## STAFF REPORT

**To:** County Manger (CM)  
**From:** Tiffanie Northrup-Robinson, County Planner  
**Date of Meeting:** September 29, 2016  
**Type of Item:** Lift (RC22) Final Site Plan – Public Hearing, Possible Action  
**Process:** Administrative Review

Project Name: Lift (RC22) - Final Site Plan  
Applicant(s): Gary Raymond, authorized representative  
Property Owner(s): One Canyons, LLC  
Location: 2431 High Mountain Road, Canyons Village  
Zone District: Specially Planned Area (SPA)  
Parcel Number and Size: Parcel #RCDA-RC22, 1.63 acres  
Type of Process: Administrative  
Final Land Use Authority: County Manager

SHEET TITLE:  
 OVERALL SITE AND  
 GRADING PLAN

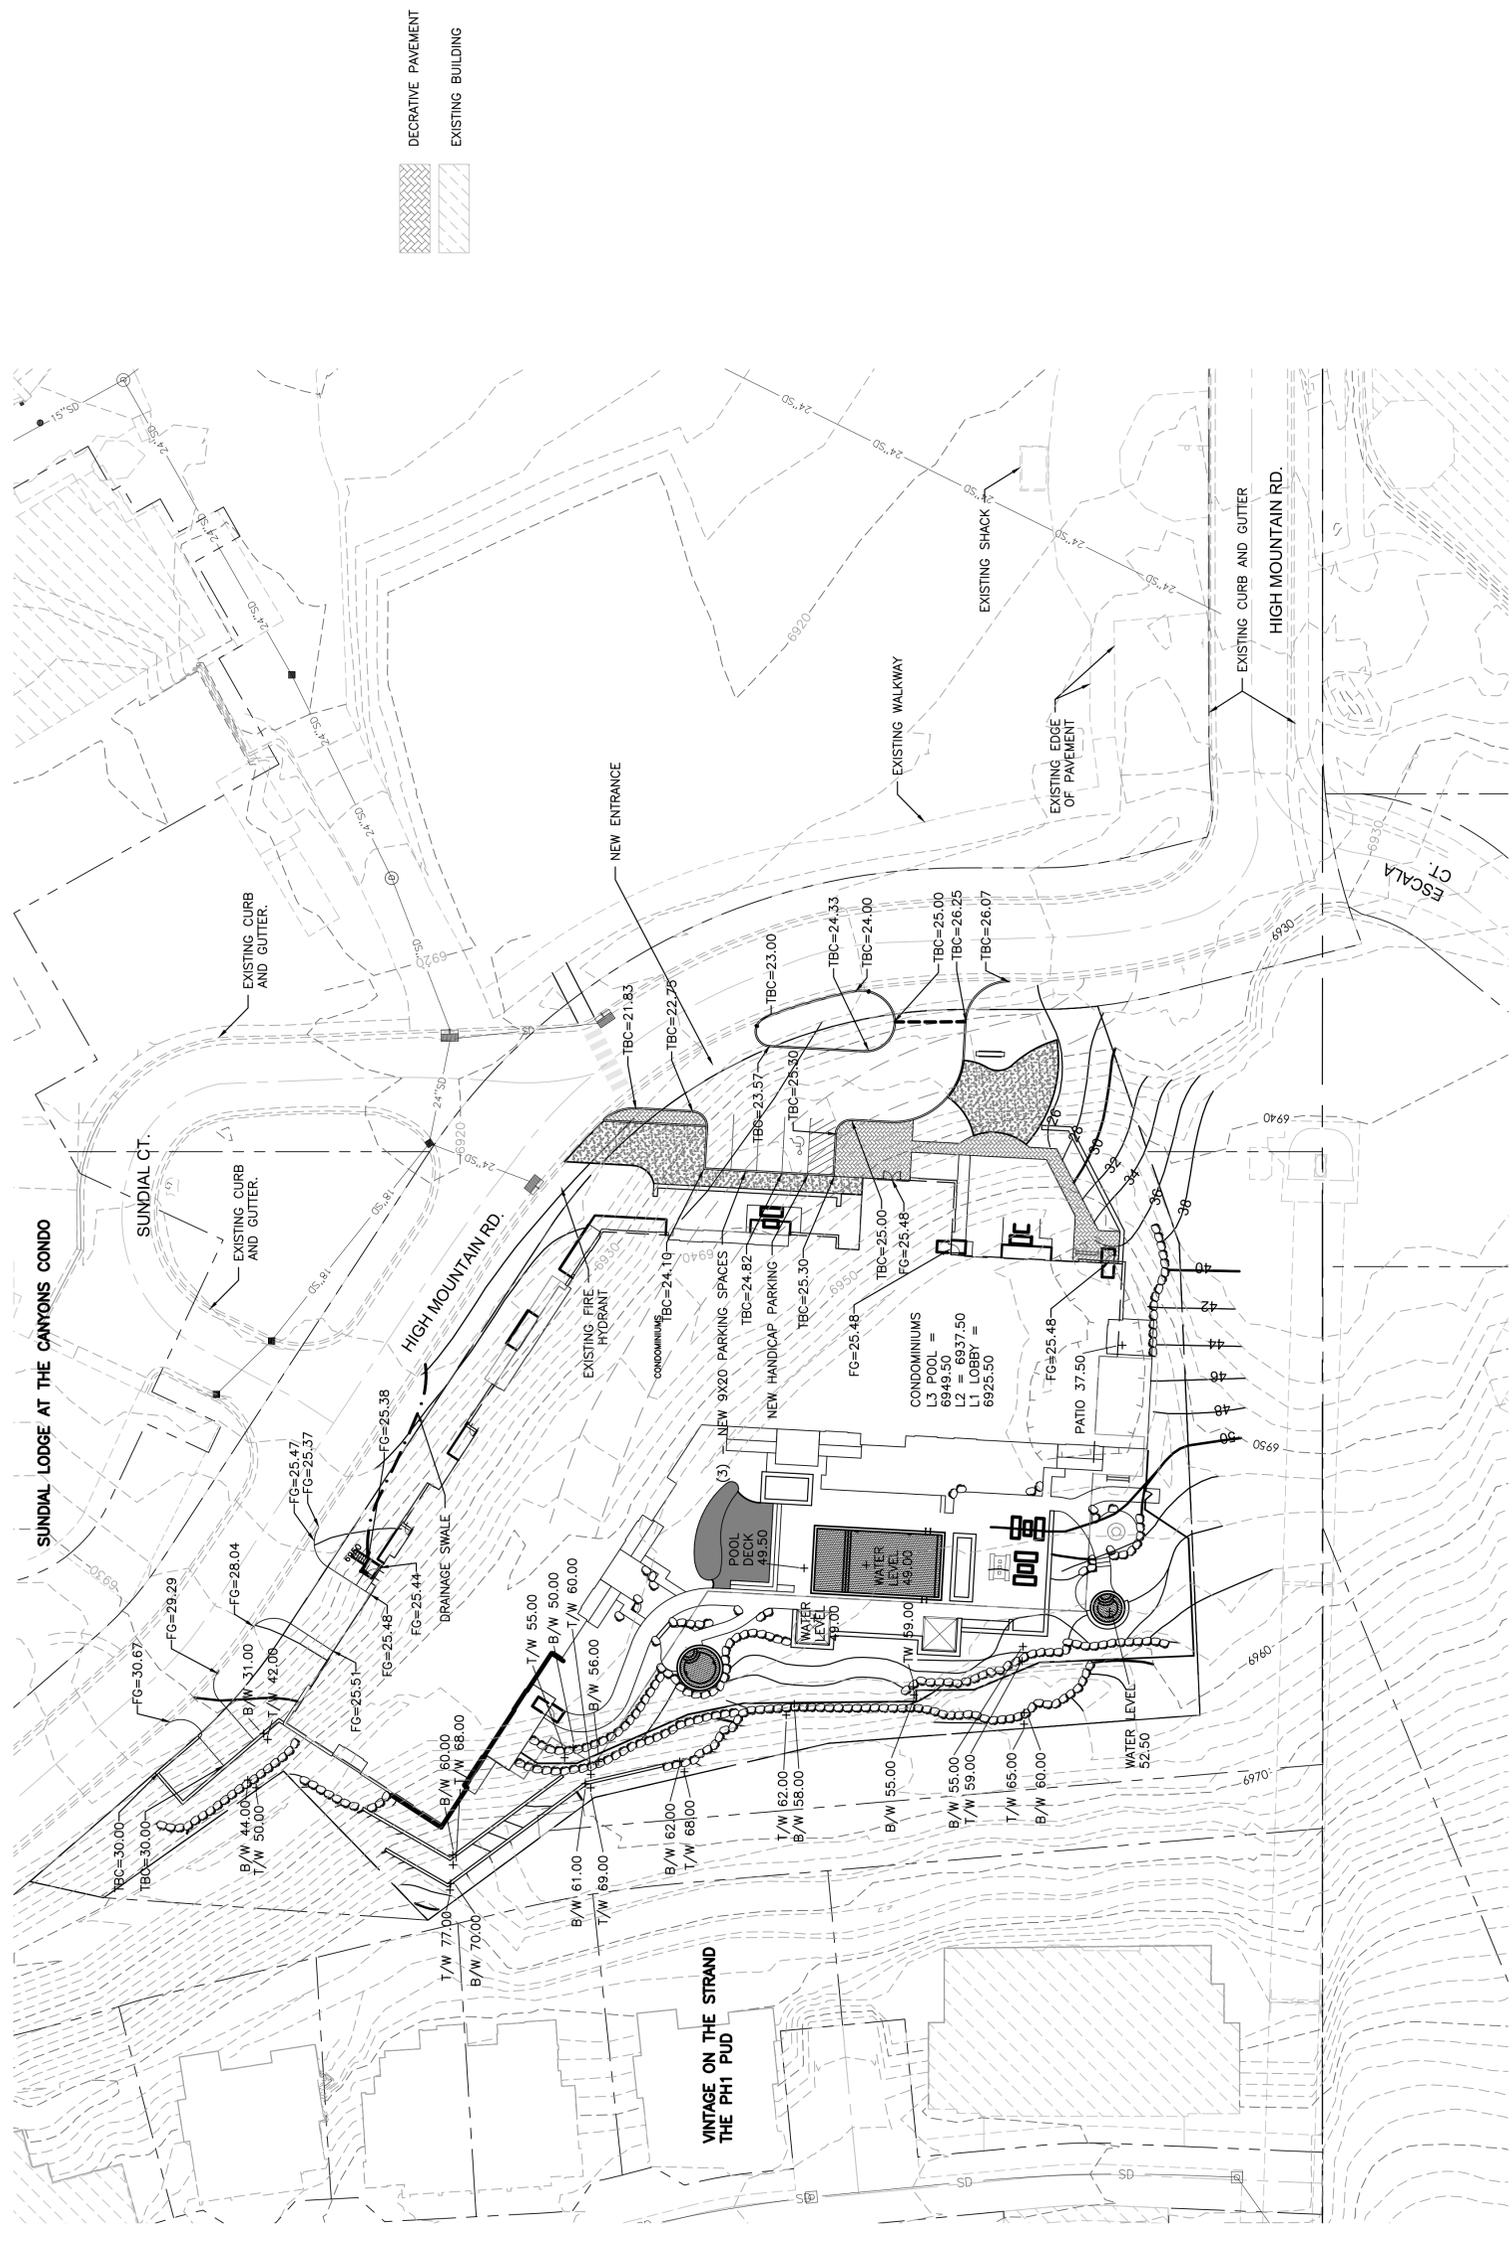
9. Transportation Infrastructure and Access Design	Based on Ord. 181, the Summit County Engineer stated that the driveway access to the parking structure be separated by at least 50 ft. from the Sundial driveway access .The applicant has modified the site plan to meet the necessary driveway separation requirements, as requested by the County Engineer.	<b>COMPLIES, as conditioned</b>

The next Engineering Department concern was the access. According to ordinance 181, the driveway can't be any closer than 50 feet from the Sun Dial driveway access. In the original site plan, the access point to the Sun Dial lodge was closer than allowed, so this has been modified.

Using the site plan, Planner Northrup-Robinson pointed out the access to the parking garage, located further up High Mountain Road. She said there are two driveways here. One is for the parking garage; the other is for the generators. The applicant, Gary Raymond, said they will have this consolidated or redesigned. Planner Northrup-Robinson said this will be a condition of approval.
